**From:** Miller, Ed  
**Sent:** Thursday, May 02, 2013 3:57 PM  
**To:** Miller, Ed  
**Subject:** files from May 2 meeting

## Dam Failure ISG - NRC Response to NEI Comments – Last Updated 4/15/13

Figure 2. Overview of Detailed Dam Failure Flood Hazard Analysis

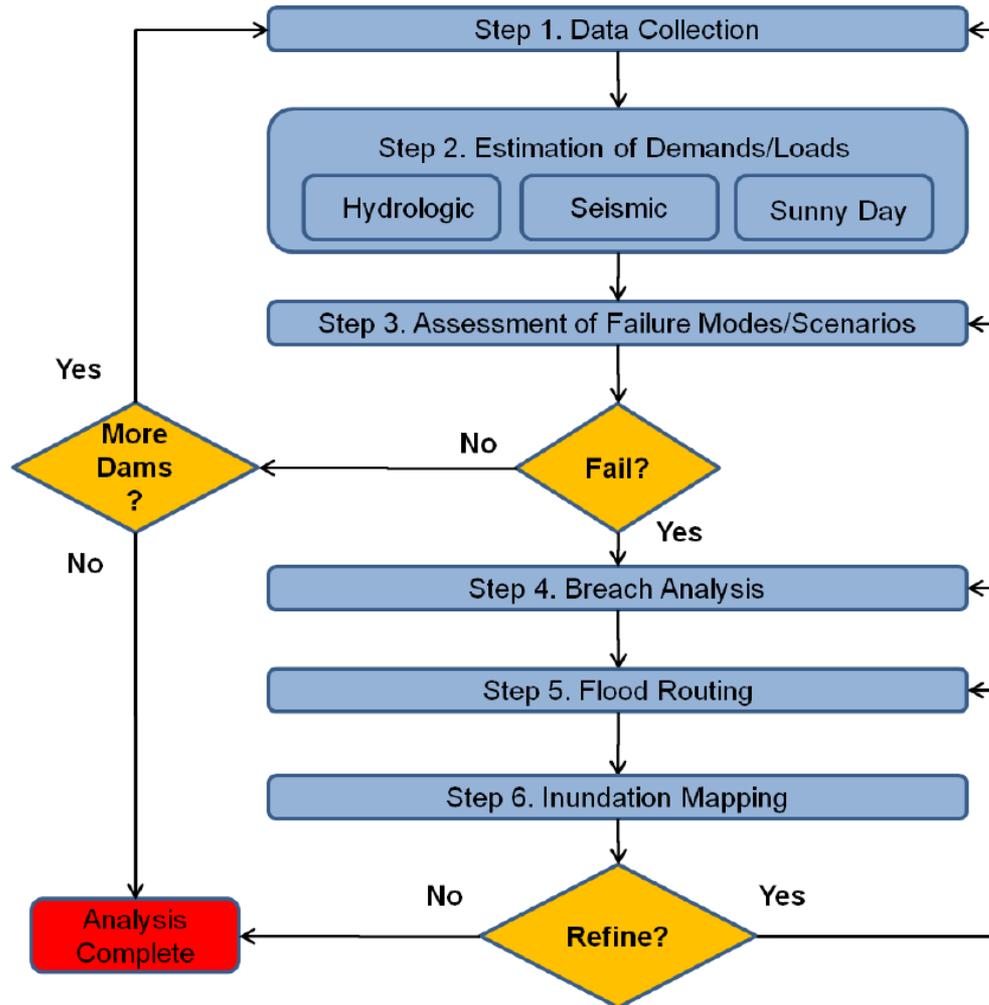
| Section / Page    | Comment  | Concern   | Proposed Resolution   | [Draft] NRC Response  |
|-------------------|--|---|---|---|
| Page 6, Figure 2  | Decision diamond on Figure 2   | What are the criteria for determining a yes or no outcome of the “Fail?” decision diamond?  |   | This is overview. Refer to sections on detailed analysis (4,5,6,7,8,9.)<br><br>No change to text.   |
